Project	<b>IEEE 802.16 Broadband Wireless Access Working Group</b> < <a href="http://ieee802.org/16">http://ieee802.org/16</a> >	
Title	<b>Modification of HO process SDLs</b>	
Data Submitted	<b>2004-06-25</b>	
Source(s)	Jaesun Cha Sungcheol Chang ETRI 161, Gajeong-dong, Yuseong-Gu, Daejeon, 305-350, Korea	Voice: +82-42-860-5587 Fax: +82-42-861-1966 <a href="mailto:jscha@etri.re.kr">jscha@etri.re.kr</a> <a href="mailto:scchang@etri.re.kr">scchang@etri.re.kr</a>
Re:	This is a response to a Call for comments about IEEE802.16e-D3	
Abstract	The document contains suggestions on modification of HO process SDLs	
Purpose	The document is submitted for review by 802.16e Working Group members	
Notice	This document has been prepared to assist IEEE 802.16. It is offered as a basis for discussion and is not binding on the contributing individual(s) or organization(s). The material in this document is subject to change in form and content after further study. The contributor(s) reserve(s) the right to add, amend or withdraw material contained herein.

## Modification of HO process SDLs

### 2. Proposed changes to IEEE 802.16e-D3

Figure 130k – locally initiated transaction MOB\_BSHO-RSP pending state flow diagram

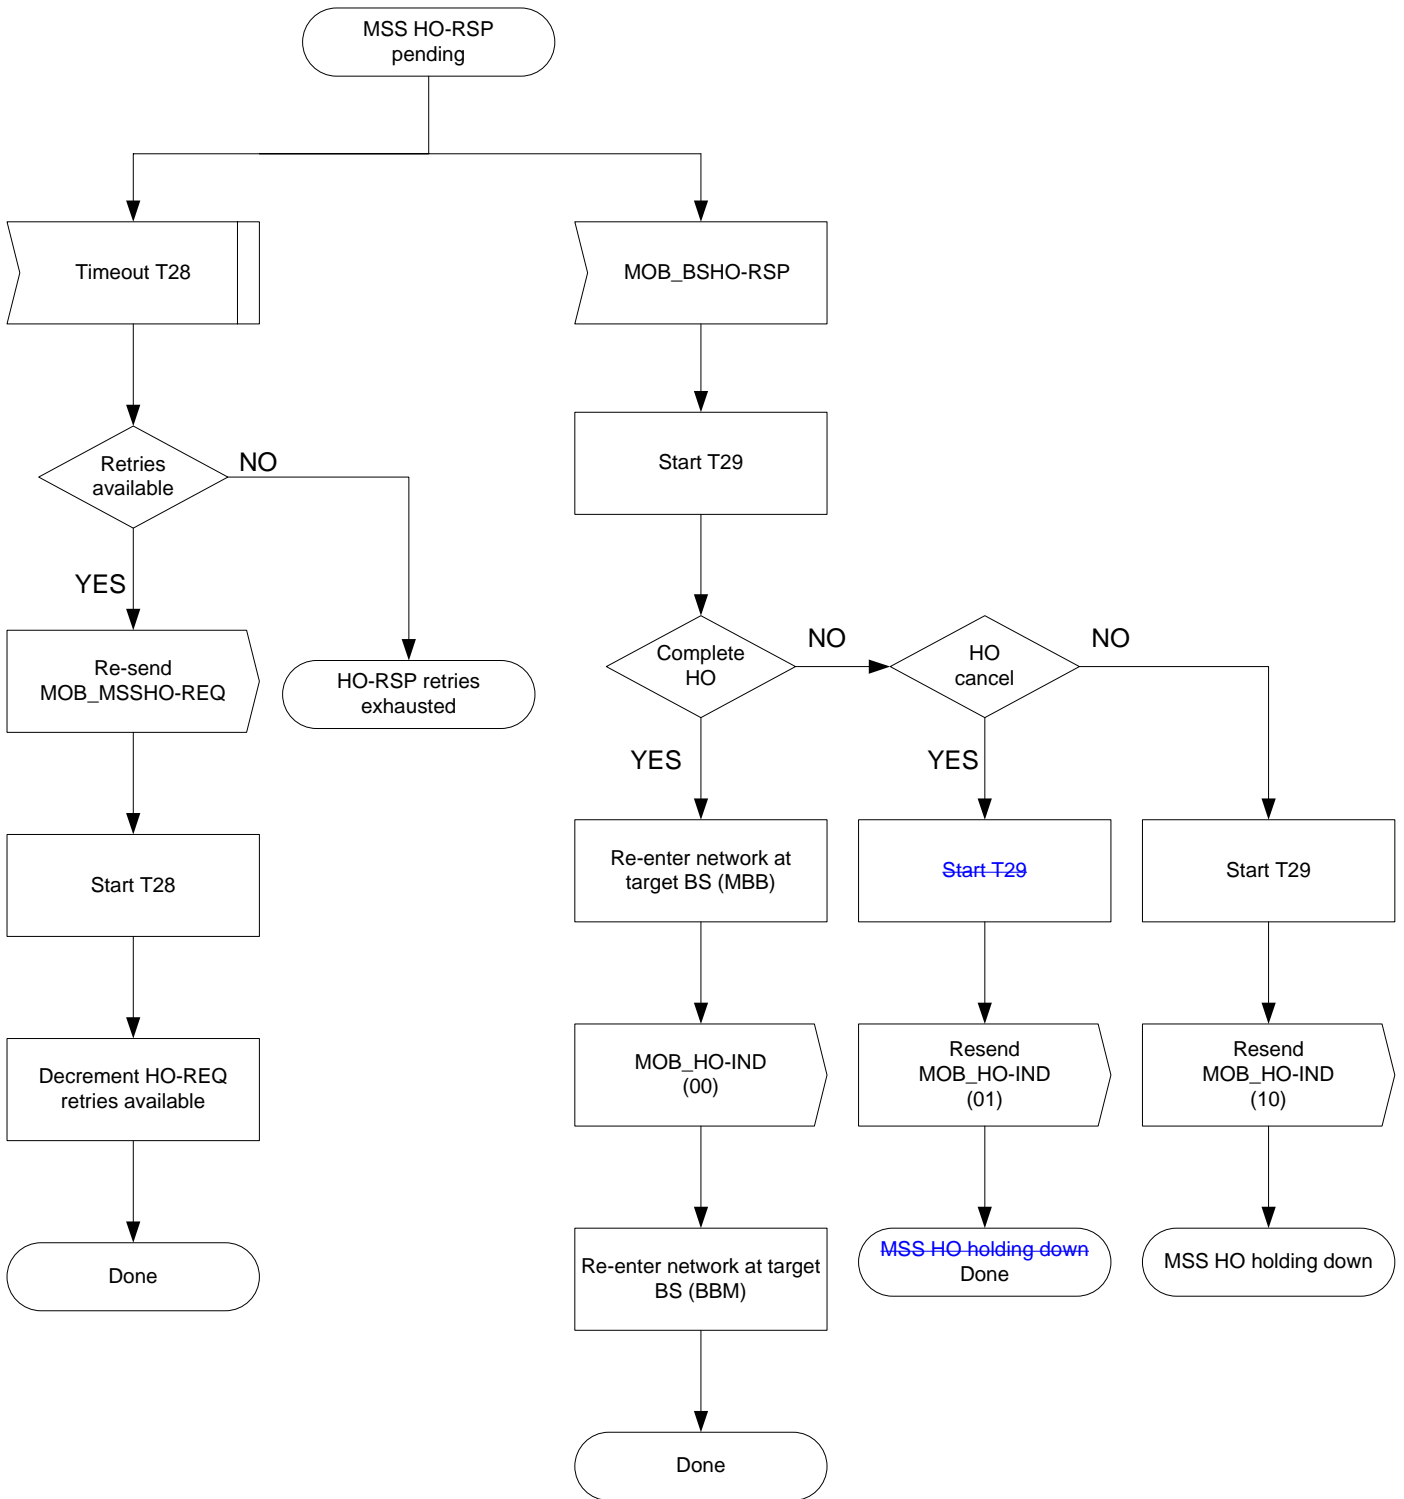
*[Change Figure 130k – locally initiated transaction MOB\_BSHO-RSP pending state flow diagram]*

Figure 1301 – MSS Handoff locally initiated transaction holding state flow diagram

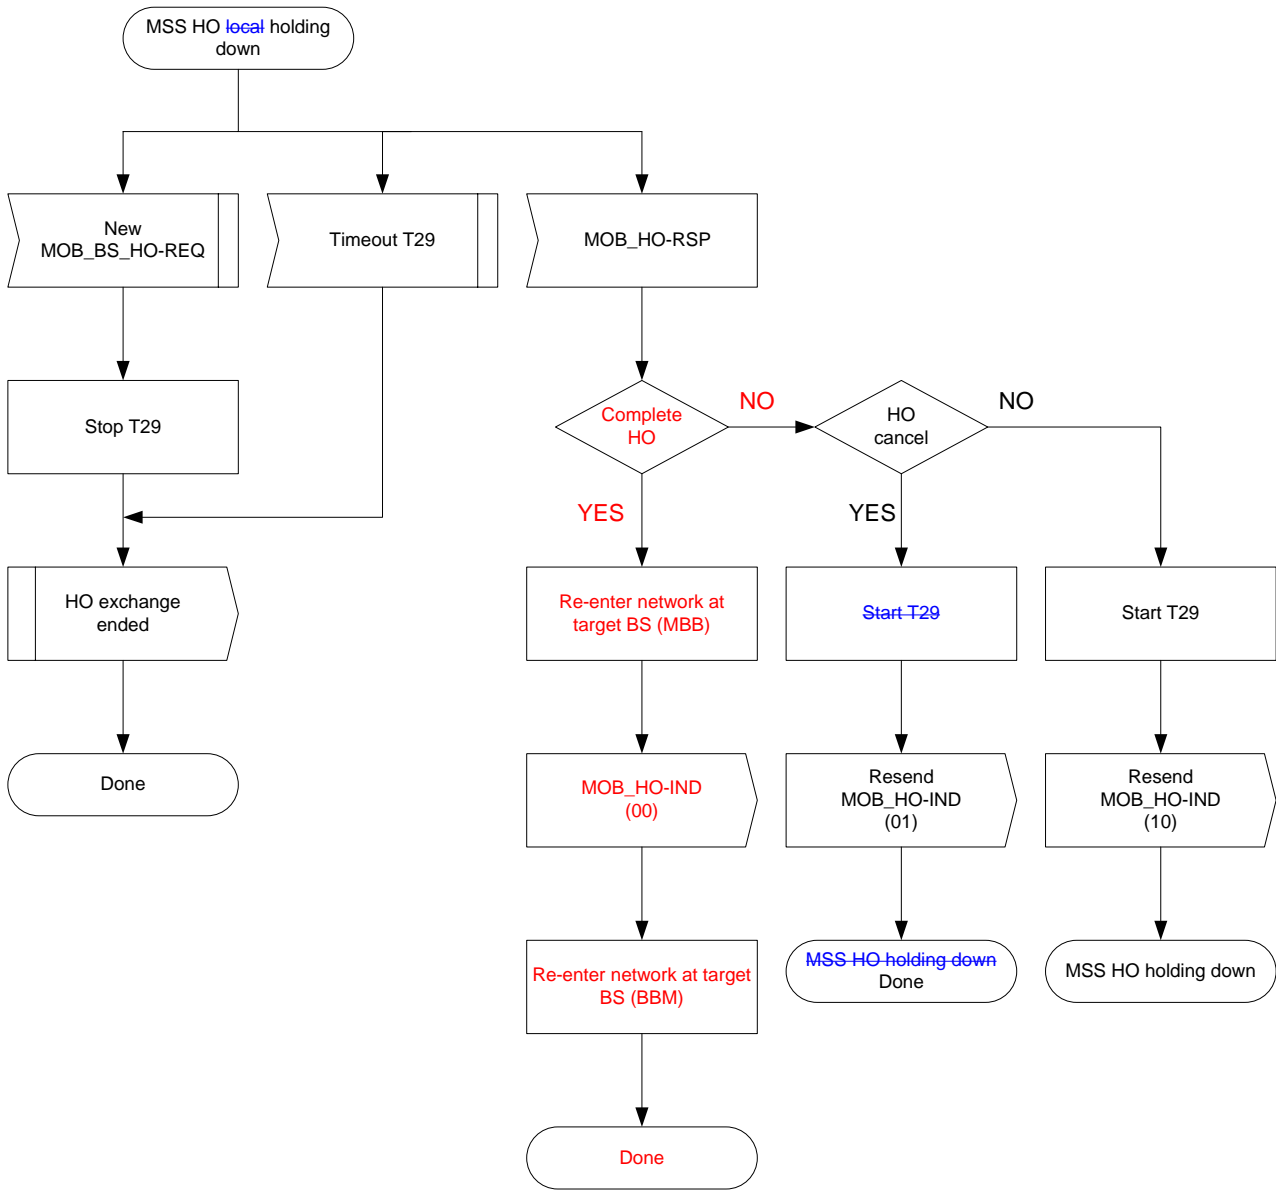
[Change Figure 1301 – MSS Handoff locally initiated transaction holding state flow diagram]

Figure 130m – locally initiated transaction MOB\_BSHO-RSP pending state flow diagram

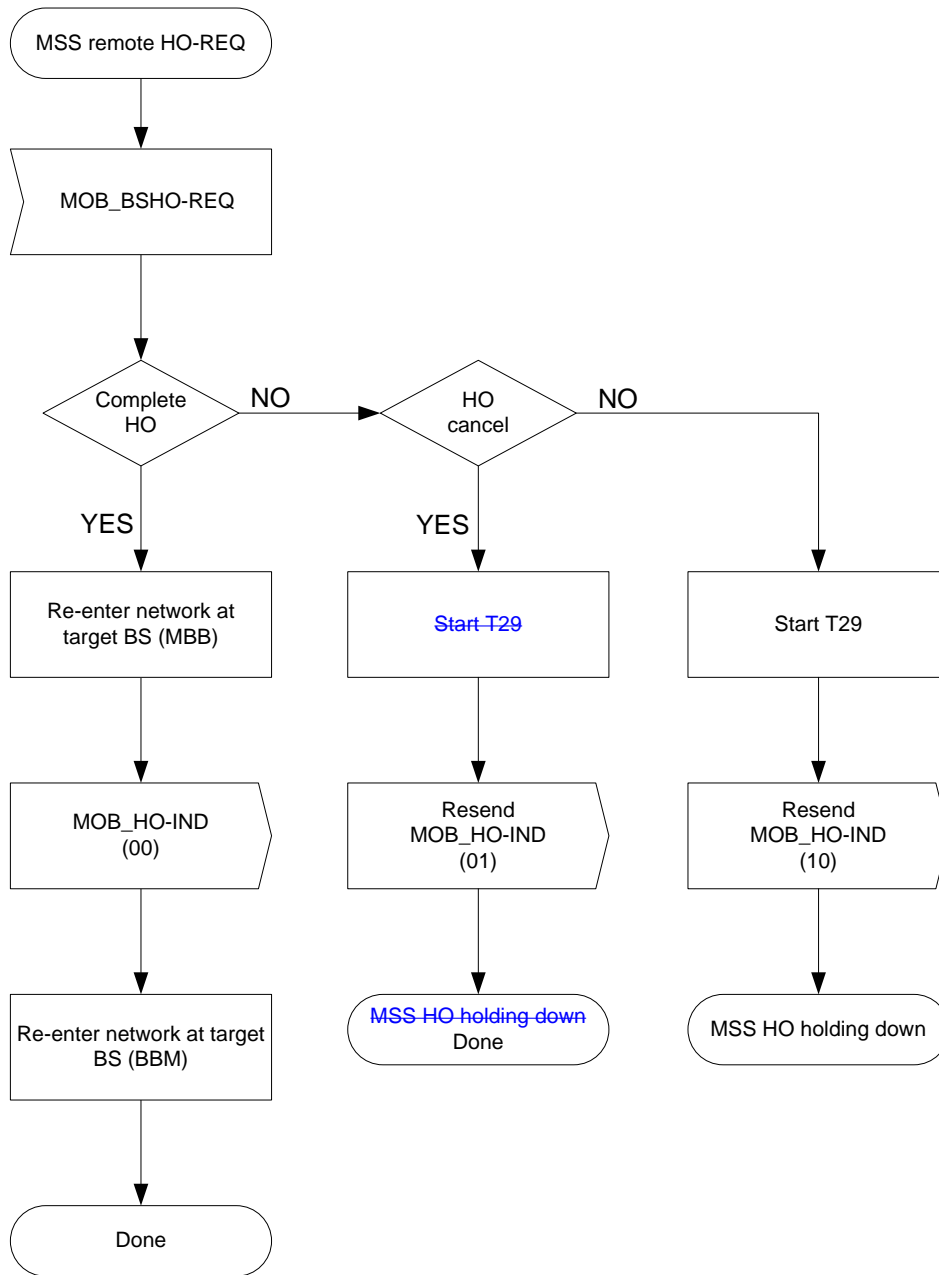
[Change Figure 130m –locally initiated transaction MOB\_BSHO-RSP pending state flow diagram]
